REGENCY LAKES
AN ADDITION TO WICHITA, SEDGWICK COUNTY, KANSAS

RE: S/D 96-22, Final Plat of the Regency Lakes Addition

CASE NUMBER: S/D 96-22 REGENCY LAKES ADDITION

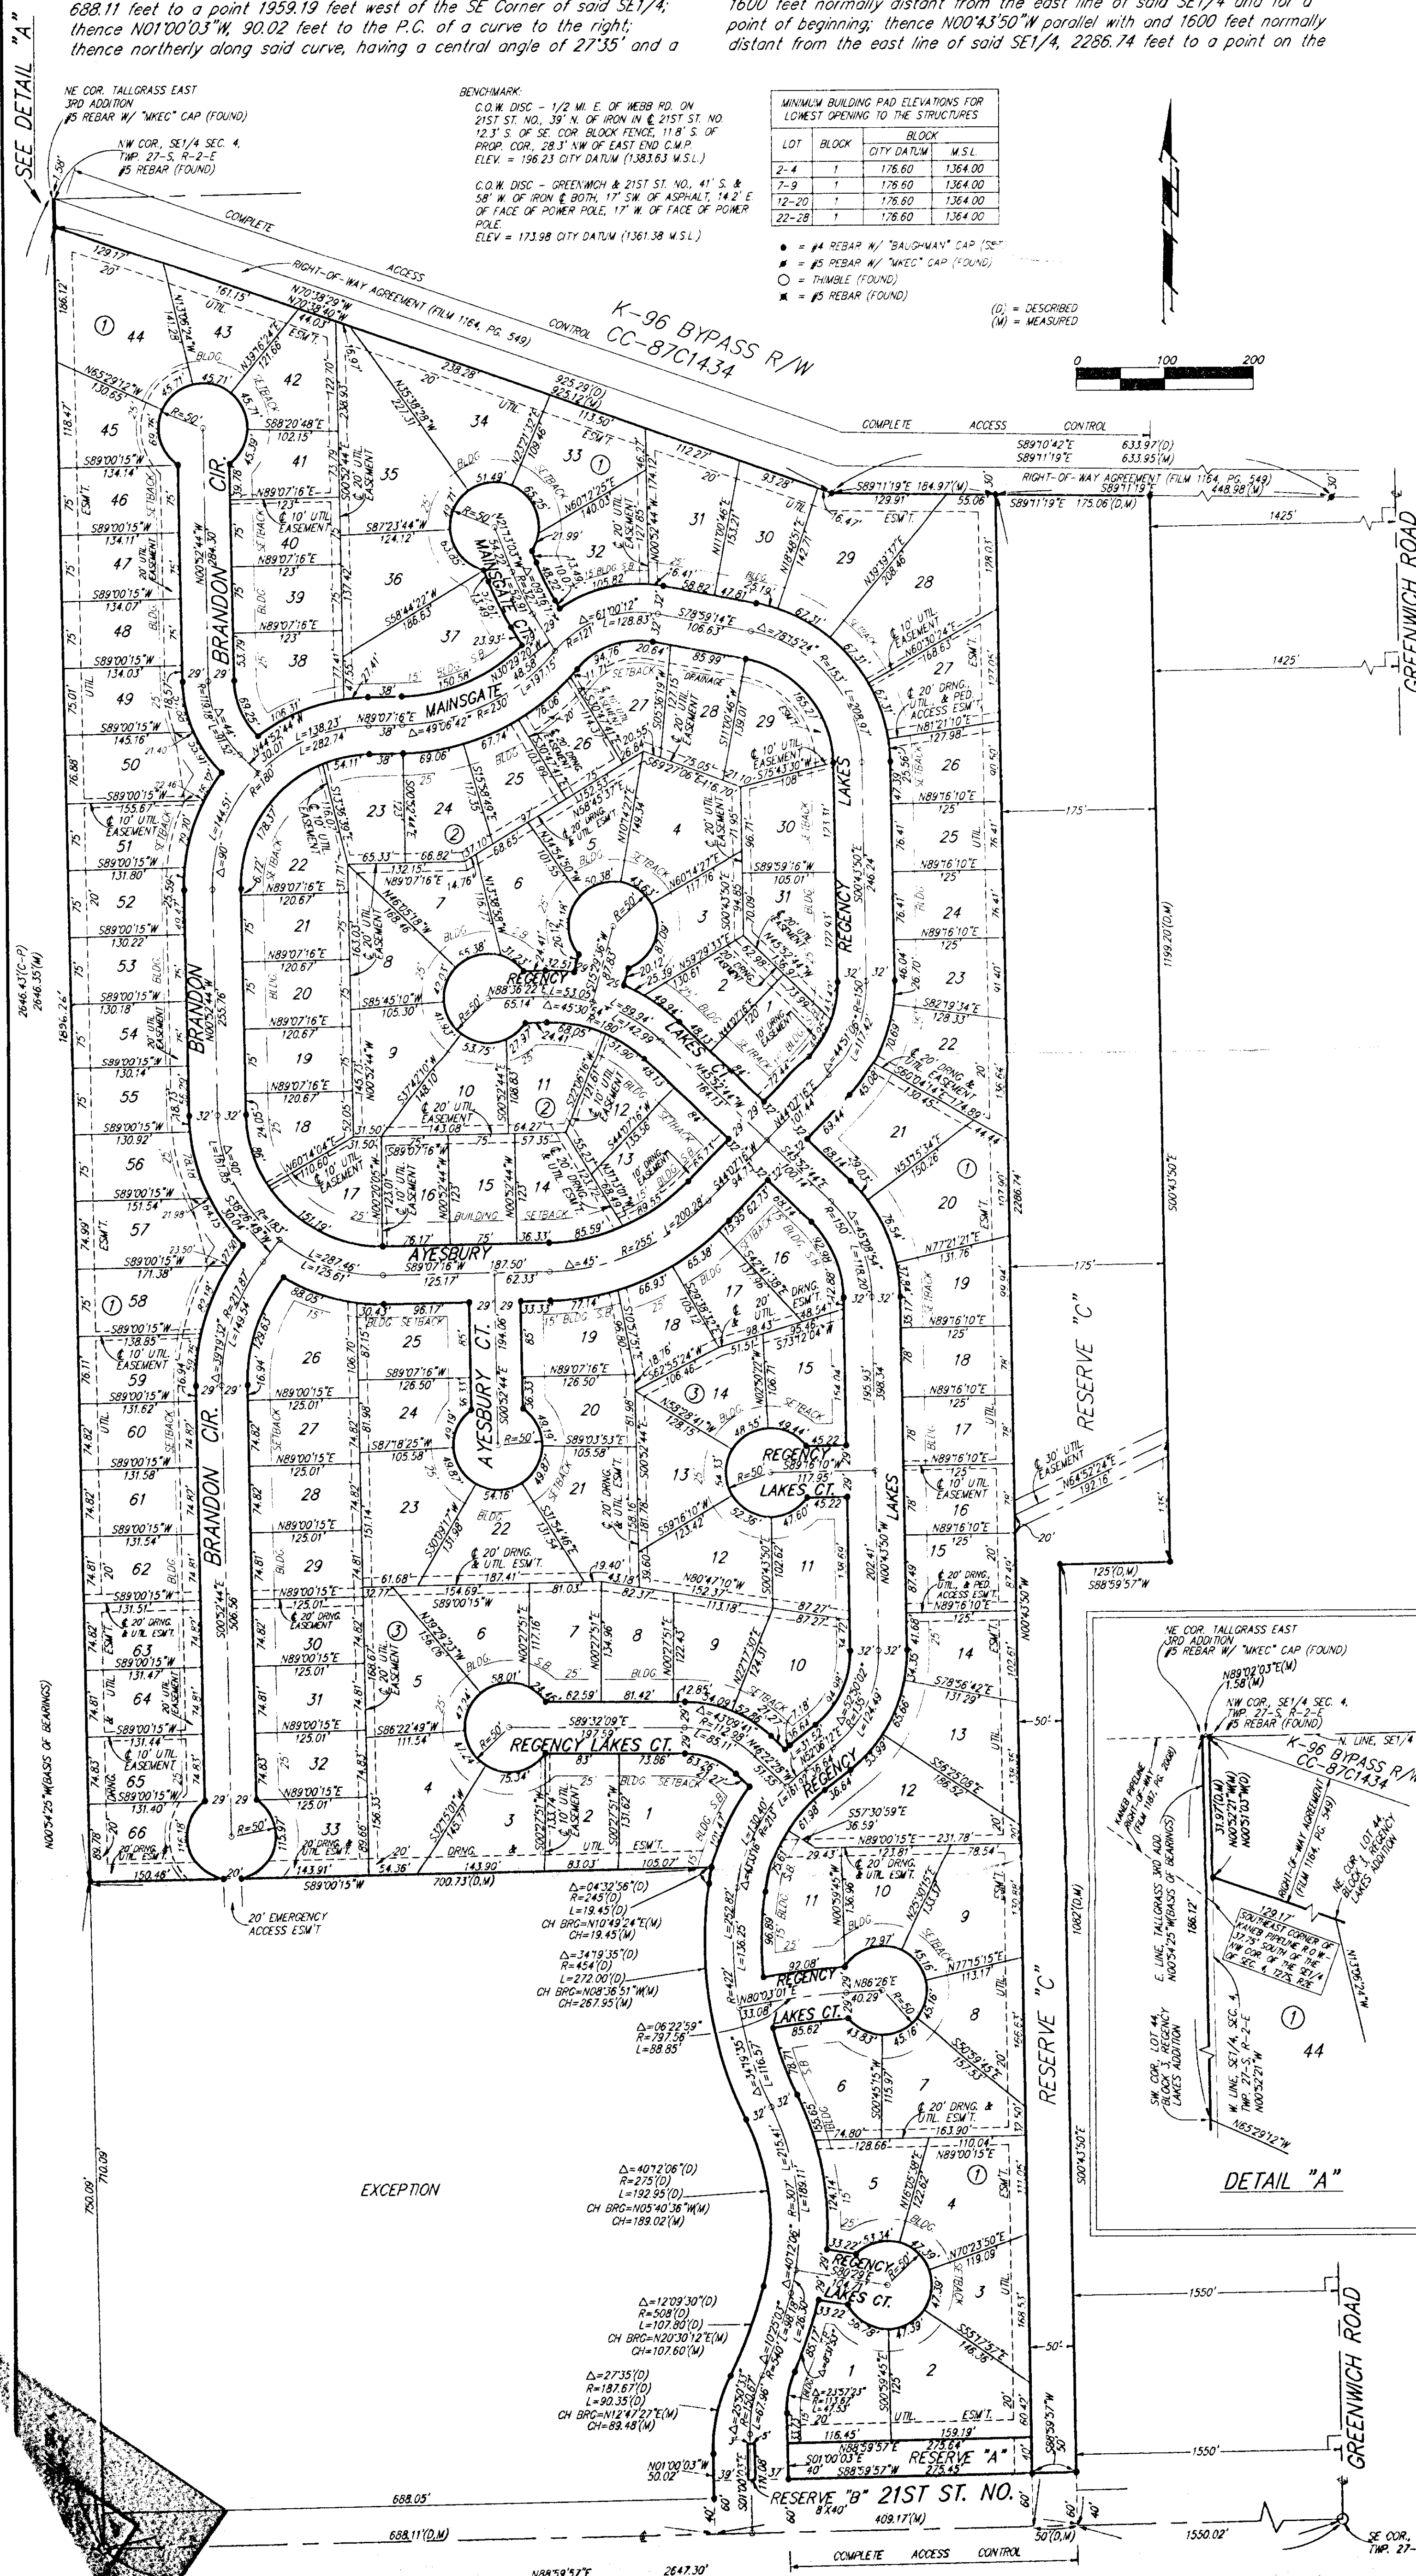
- A. As requested by the applicant, the final plat tracing may include, as a Reserve, the area along this plat's east line. The plat shall note the purpose or uses for this Reserve. Also, at least 2 or 3 means of access shall be provided from this Reserve, westward into the residential areas.

- C. The applicant shall guarantee the extension of sanitary sewer to serve the lots being platted. As noted by Planning and City Engineering, sewer service may not be possible at this time and completion of this plat to the City Council may be subject to the availability of sewer to this site. As needed, off-site utility easements shall be provided for extension of sanitary sewer. *Being provided by Greenwich Street*

- D. The applicant shall guarantee the extension of City water to serve the lots being platted. The applicant needs to contact the Water Department and City Engineering to determine if and how this site can be served at this time.

- E. The applicant shall guarantee the paving of the proposed interior streets. In addition, this guarantee shall provide for sidewalk on at least one side of all non-cul-de-sac streets.

- F. As noted by Traffic Engineering, guarantees shall be provided for a left-turn lane in 21st Street and a right-turn lane from the site to serve the development's entrance at 21st Street. *not listed on plat. Phil says this was a dual left turn from site to 21st not an accel along 21st*

G. The applicant shall guarantee any drainage improvements required by the platting of this property. As noted by City Engineering, off-site easements, agreements and improvements will also be required for this site's drainage. In particular, additional computations for the off-site detention facility will be required. A permit from KDOT will also be needed for the drainage involving K-96. Prior to this plat being scheduled for City Council review, a revised drainage plan will need to be approved by City Engineering.

J. Since this site is now indicating only one point of access (Conceptual Plan indicated at least one additional point of access at this plat's northeast corner), for 131 residential lots, with some lots being over 2,000 feet from the site's 21st Street entrance, the applicant shall provide a means of emergency access for this development. Such access needs to be reviewed and approved by the City's Fire Department, with appropriate assurances provided for by the installation and maintenance of any improvements deemed necessary.

K. Provisions shall be made for ownership and maintenance of the proposed reserves. The applicant shall either form a lot owners' association prior to recording the plat or shall submit a covenant stating when the association will be formed, when the reserves will be deeded to the association and who is to own and maintain the reserves prior to the association taking over those responsibilities. This covenant shall also provide for the owners' association to maintain the "parking strip" located between this site's south line and the driving surface to 21st Street North.

L. The applicant shall submit a covenant which provides for four (4) off-street parking spaces per dwelling unit on each lot which abuts a 58-foot street. The covenant shall inventory the affected lots by lot and block number and shall state that the covenant runs with the land and is binding on future owners and assigns.

M. The final plat tracing shall indicate the street names requested by the City's Fire Department.

N. The applicant is advised that the configuration of Lot 6, Block 2 is somewhat awkward and may significantly hamper the positioning of a home on this lot.

~~W.~~ As requested by County Engineering, the final plat tracing shall dedicate 60 feet of right-of-way for 21st Street North (FAS route).

~~X.~~ The final plat tracing shall indicate minimum building pad elevations for lots along the plat's east line, adjacent to the detention facilities.

~~Y.~~ As requested by KG&E-Electric, the final plat tracing shall grant additional, 10-foot utility easements along the following common lot lines: Lots 58 and 59, Block 3, Lots 16 and 17 and 26 and 27, Block 2.

Phil M. noted that
certain off-site easements needed
for this plat will be provided
by the owner, Buss AK plat
i.e. hold this plat so that it can
go with that plat

will be provided by the plat of Agency Lakes Part - 1/2 of the plat

as of 3/17/97 - no such letter - however, not necessary, a plat requirement.
